River Run Unit Two Replat "A"

City of El Paso — City Plan Commission — 2/7/2019

SUSU19 - 00003 — Resubdivision Combination

ATTACHMENT 2

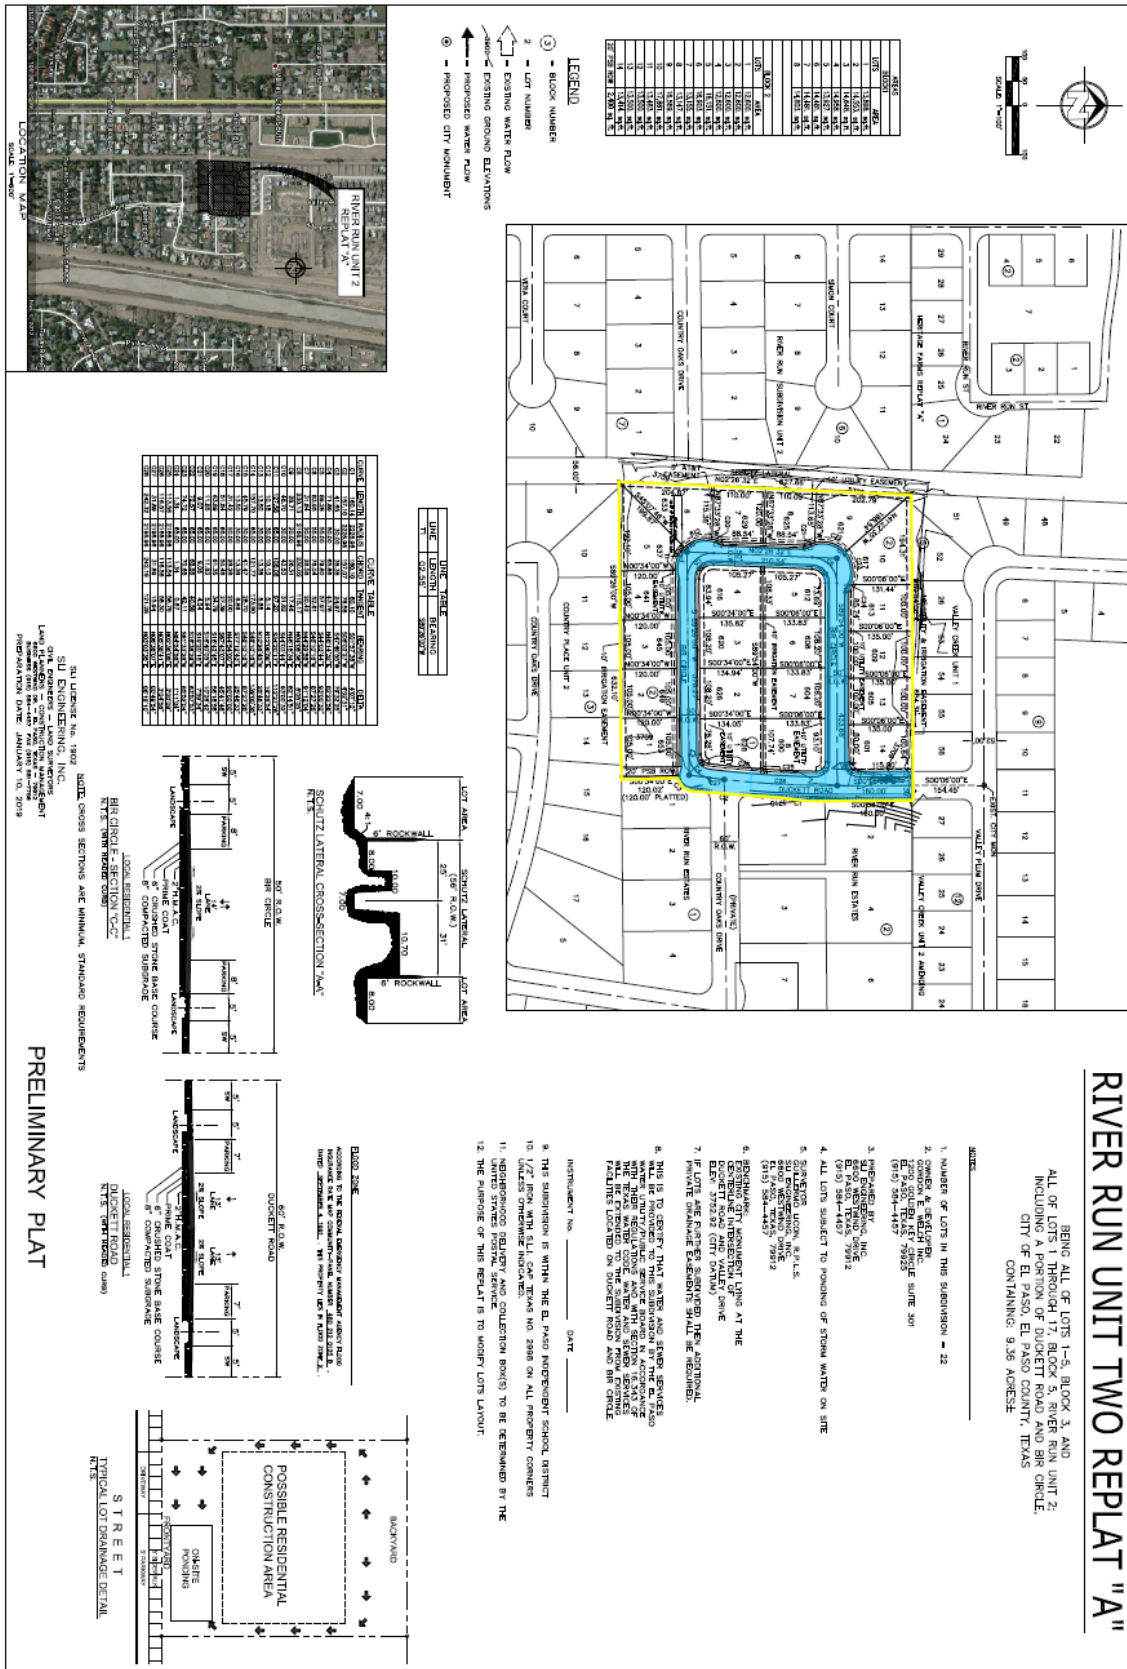
- 1. Note #5 should read: "...and shall comply with all provisions of Muni-Code Section #19.19.1a, DSC panel 1-4C, and DDM section 11.1".
- 2. At the improvement plan stage, protect the subject property from storm water runoff from the adjacent terrain.
- 3. Remove pavement thickness values on typical street cross sections.

ATTACHMENT 3

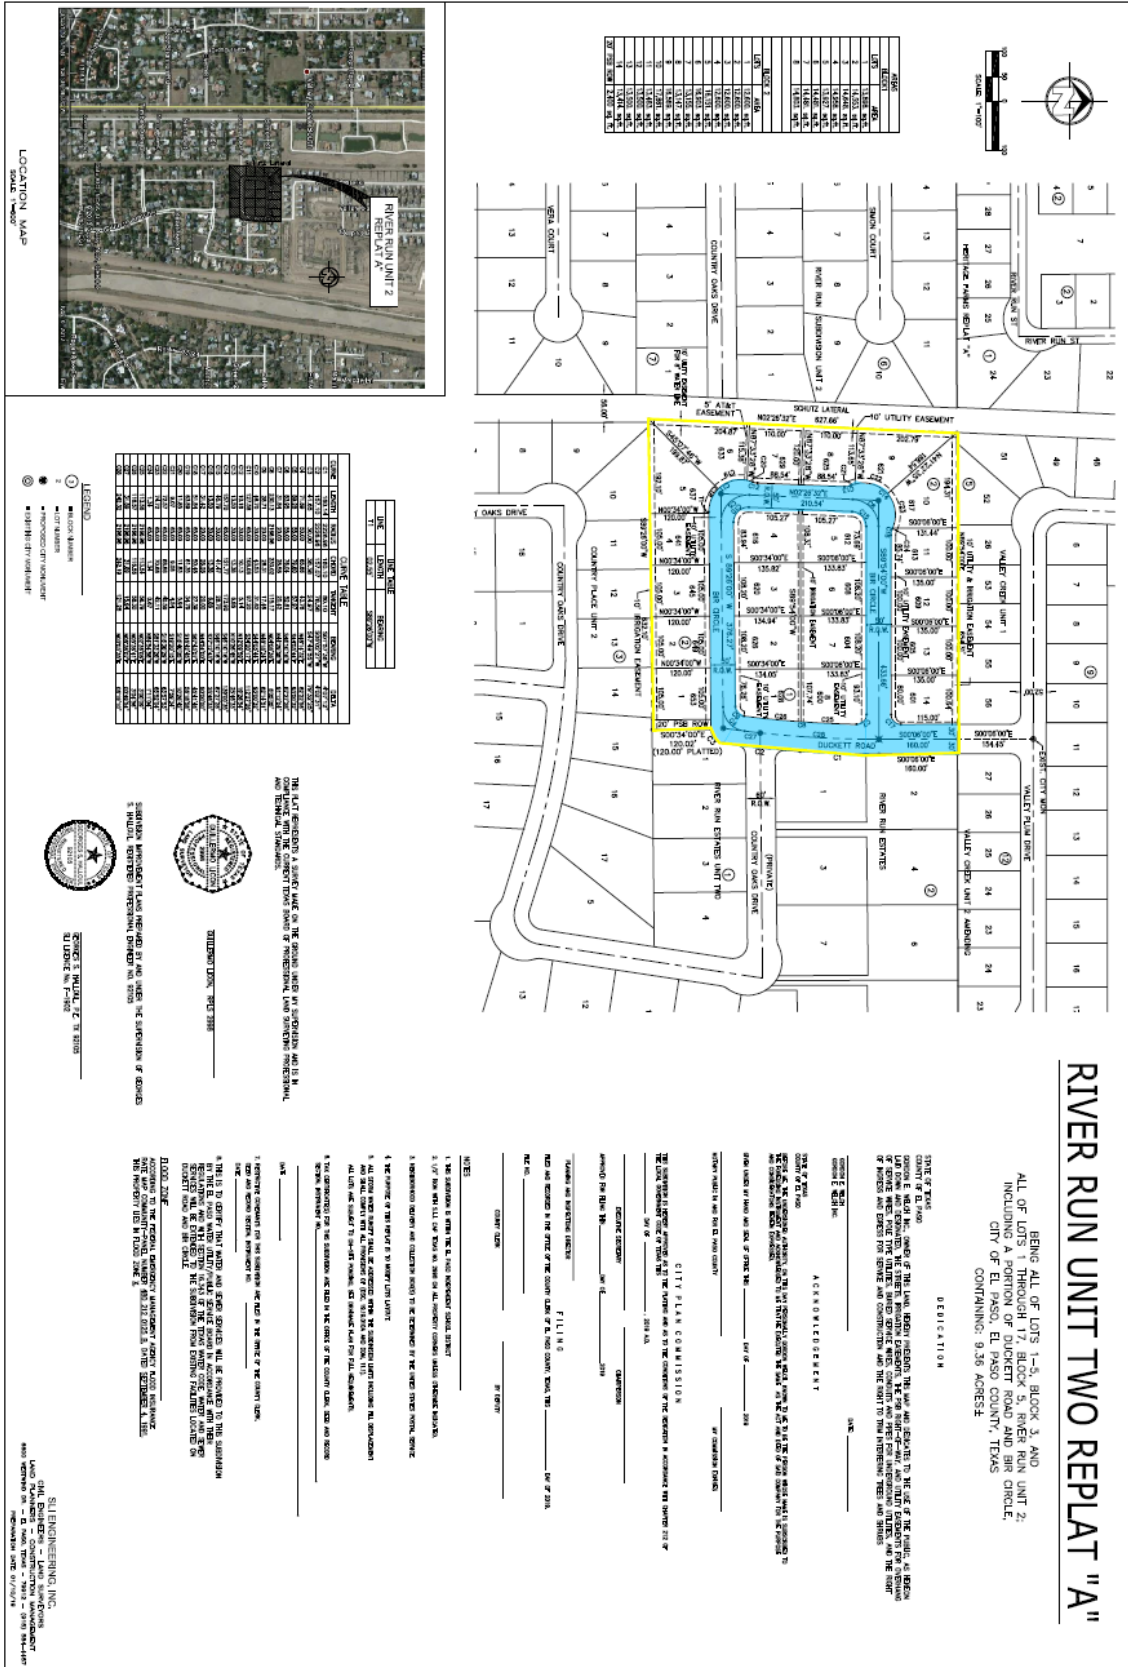
Change Block 1 to Block 10 and Block 2 to 9.
